PCS Running Disparity Comment No. 231

Draft Amendment to IEEE Std 802.3-2022
IEEE P802.3dg 100 Mb/s Long-Reach Single Pair Ethernet Task Force

IEEE Draft P802.3dg/D2.0
29th July 2025

Spectrum of Existing PAM-2 and PAM-3 Symbols

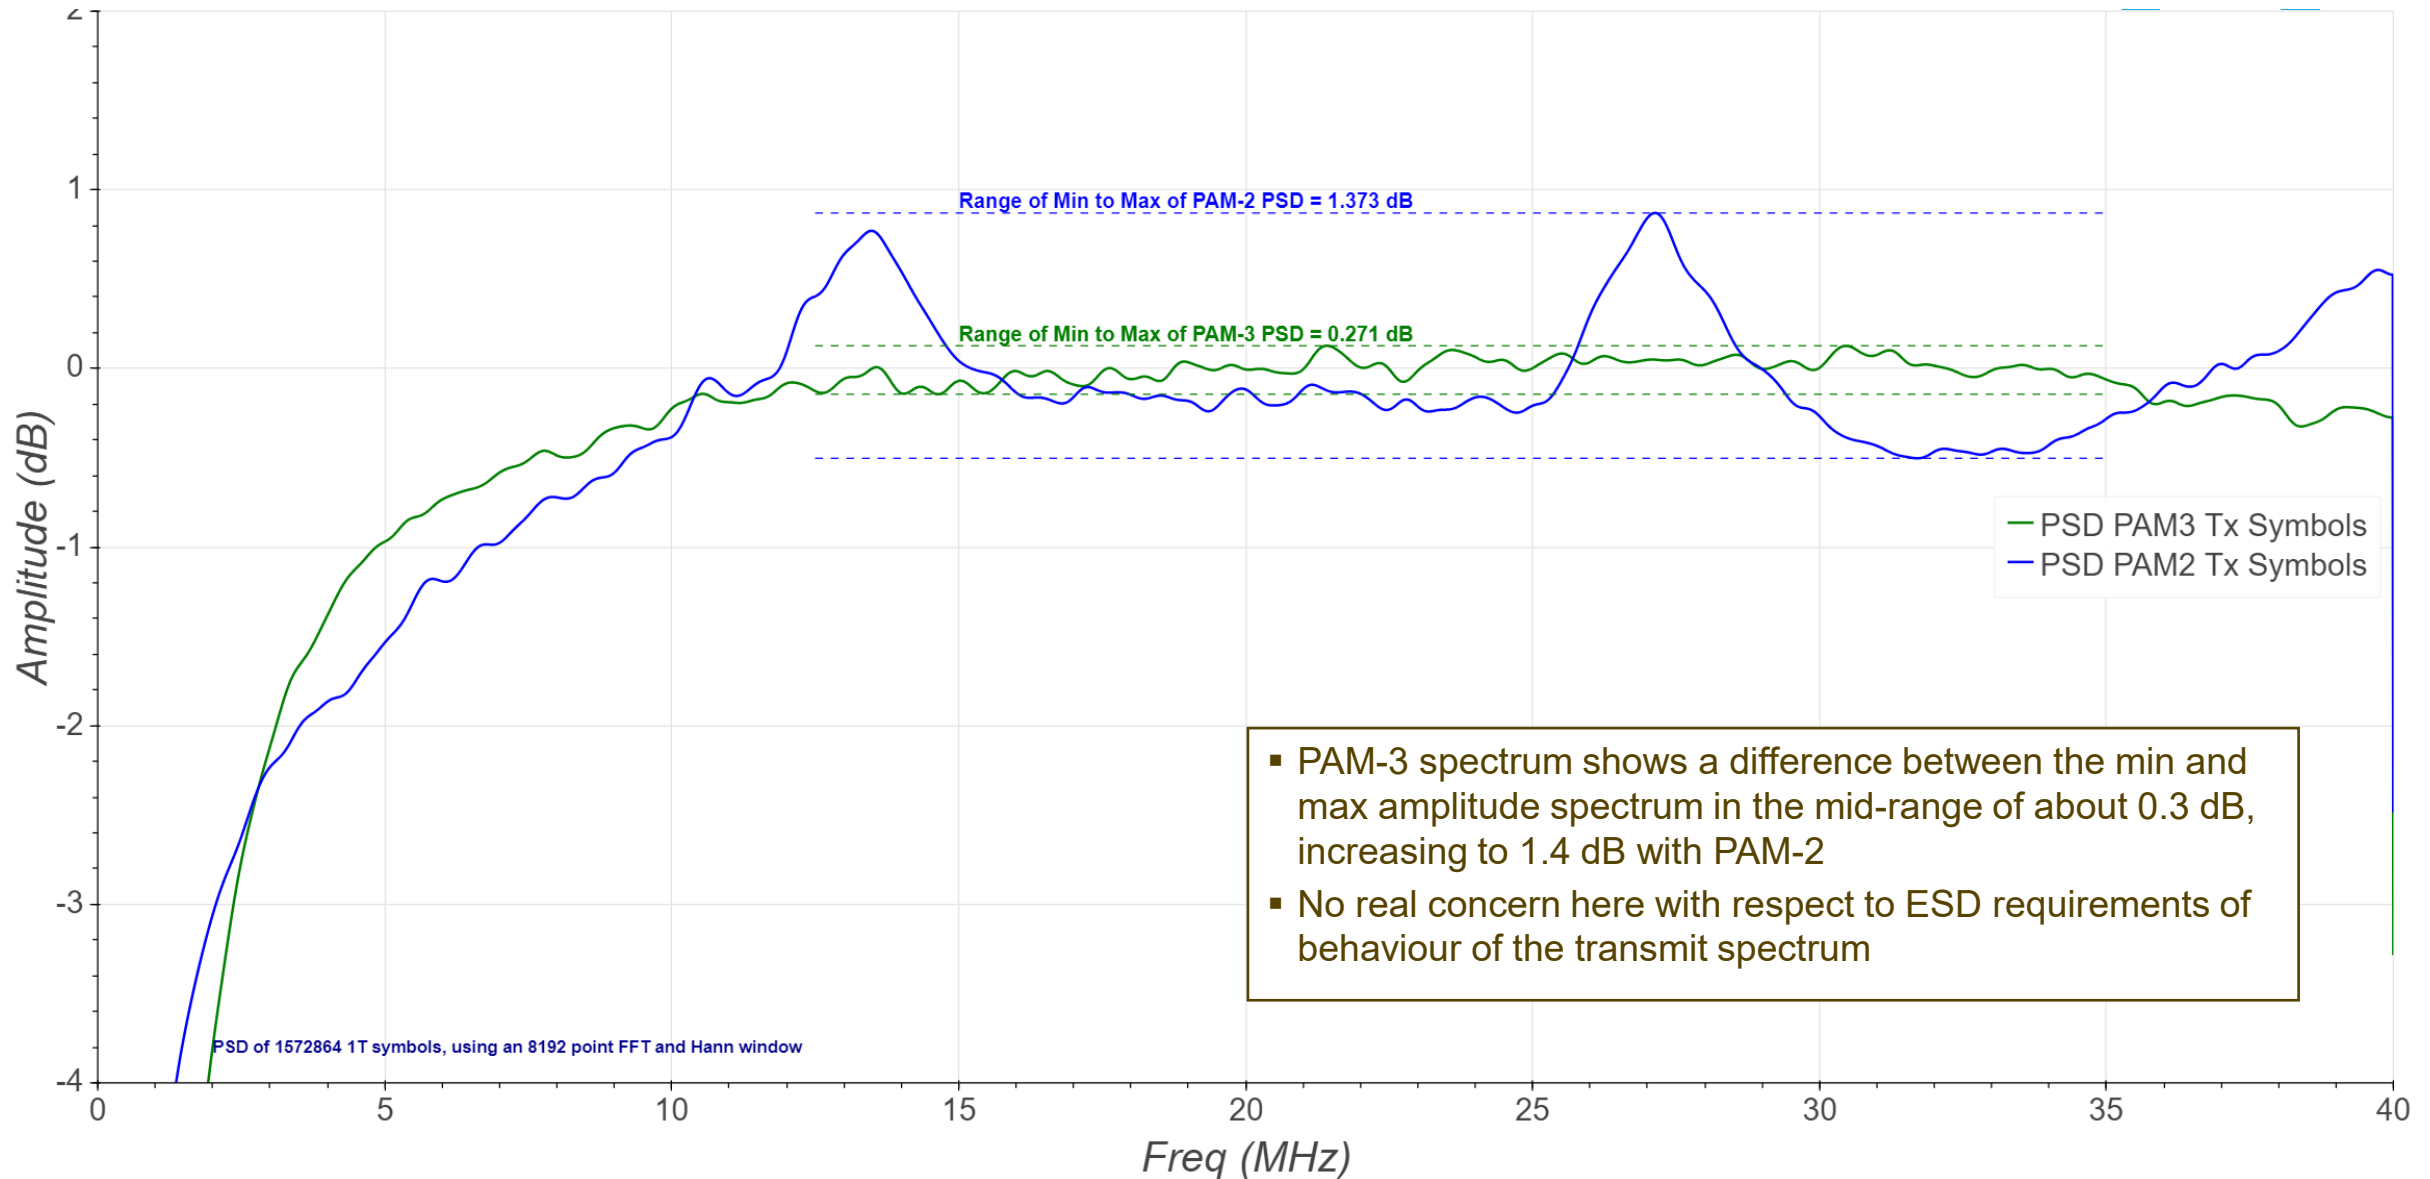
- ▶ The existing table of 4b6B NND code-groups for PAM-2 training result in a difference between the running disparity bound during PAM-2 training (+/-7) and normal operation (+/-5)

- A worse running disparity bound in training could result in increased non-linearity
- ▶ The existing PAM-2 table results in longer runs of 1's or -1's in training than during normal operation

Spectrum of PAM-2 4b6B-Swap(- + + + +) → (- + - + +)

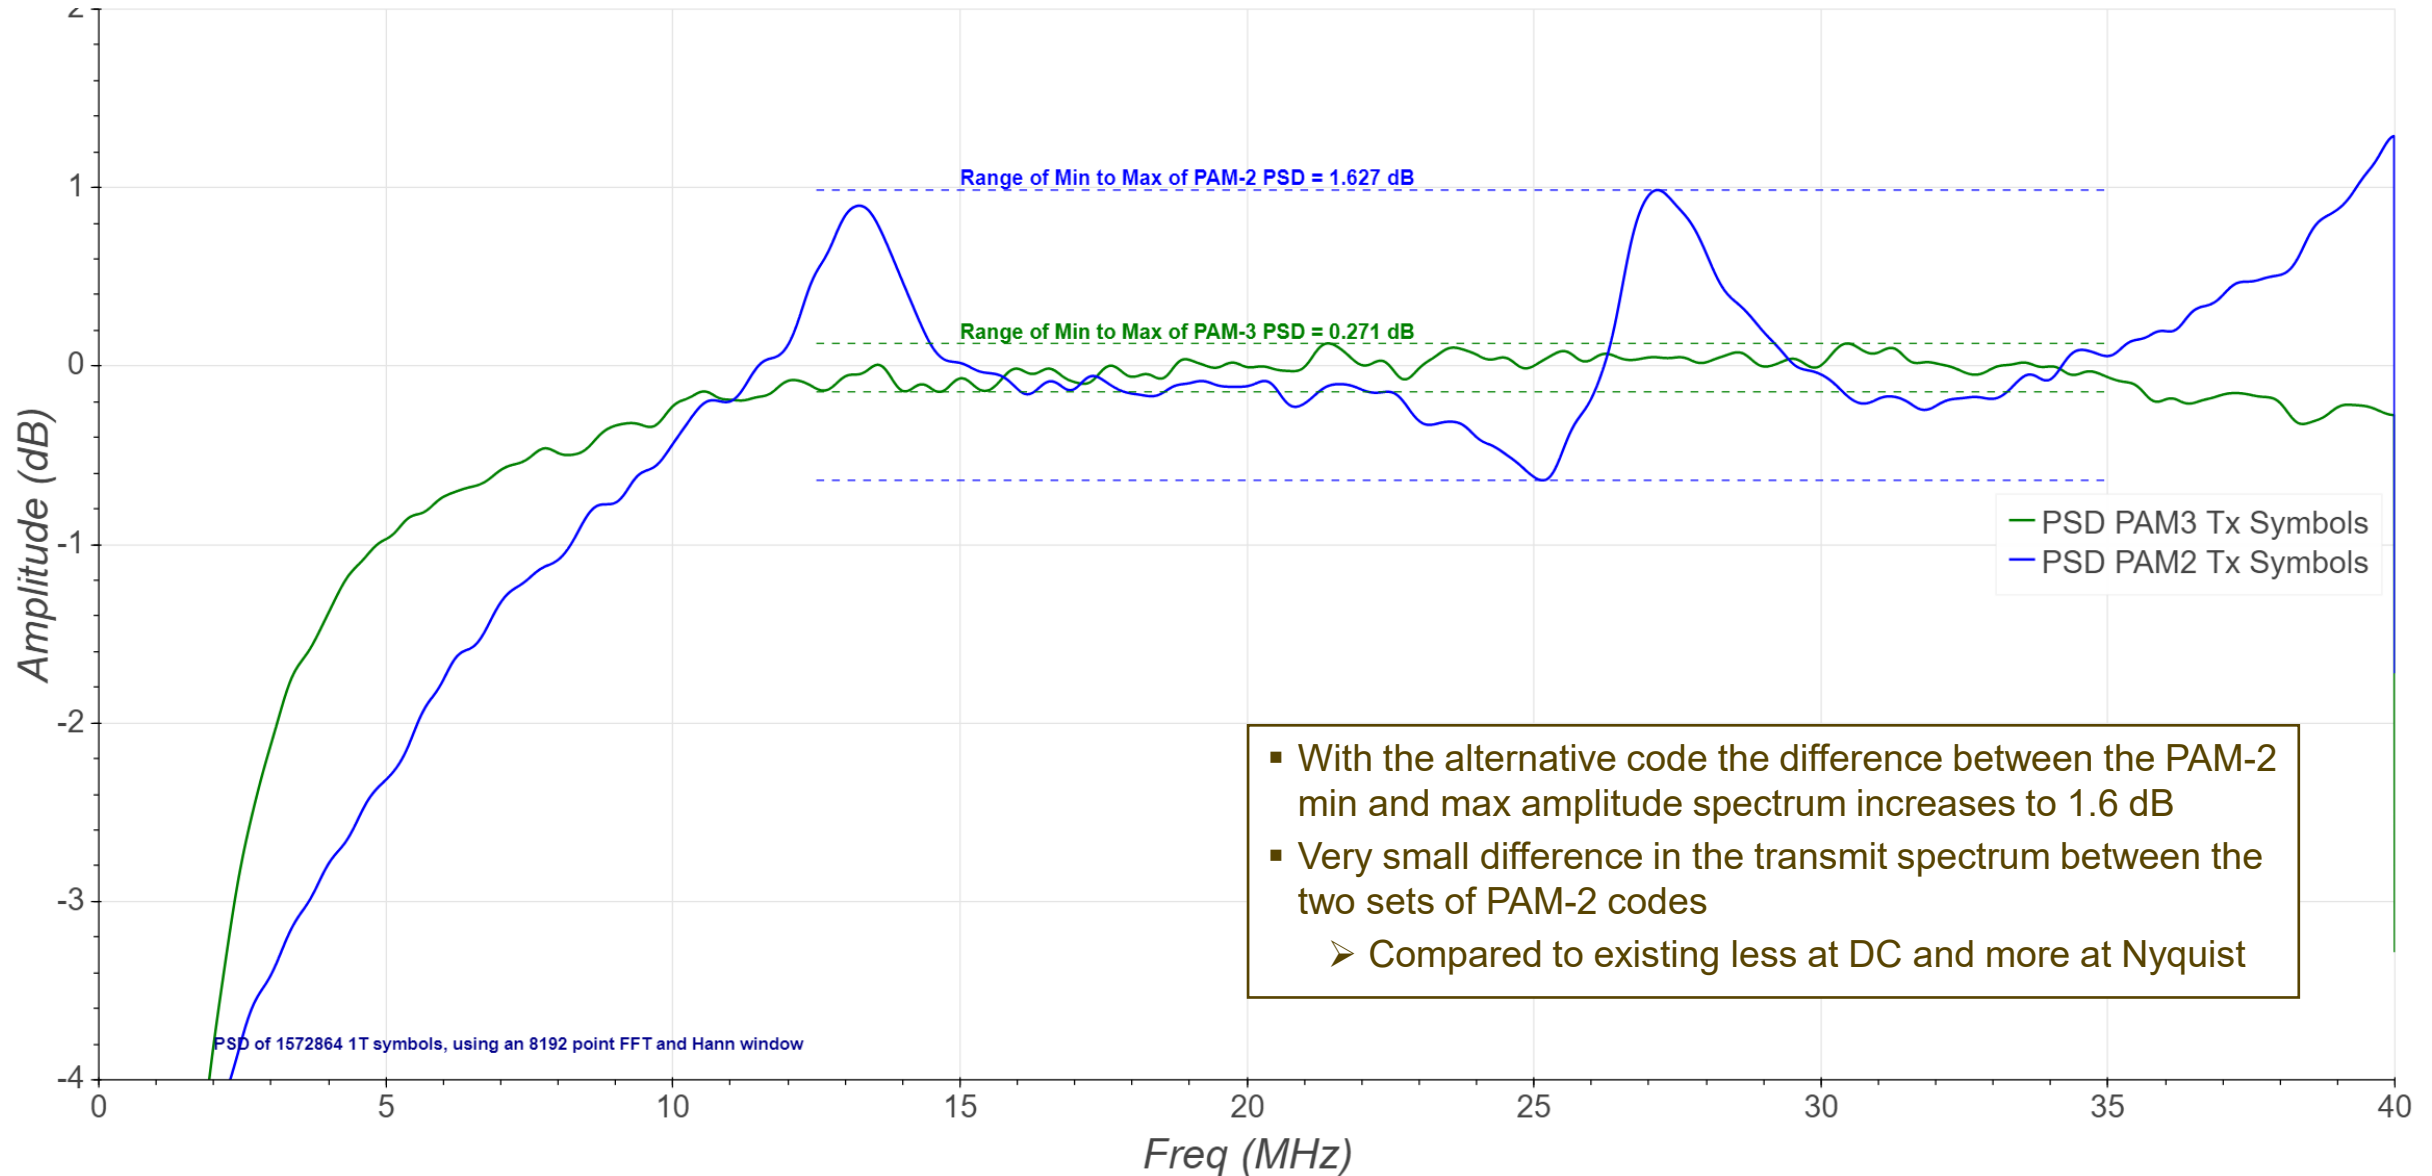
- This can easily be achieved by replacing the code with a disparity of 4 with a code of disparity 2
- So replace the 6-tuple (- + + + + +) for entry [0010] in Table 190-8 with the 6-tuple (- + - + + +)

- ▶ Comment 231 proposes a resolution to this issue by replacing the 6-tuple [-1 1 1 1 1 1] for entry [0010] in Table 190-8 with the 6-tuple [-1 1 -1 1 1 1]
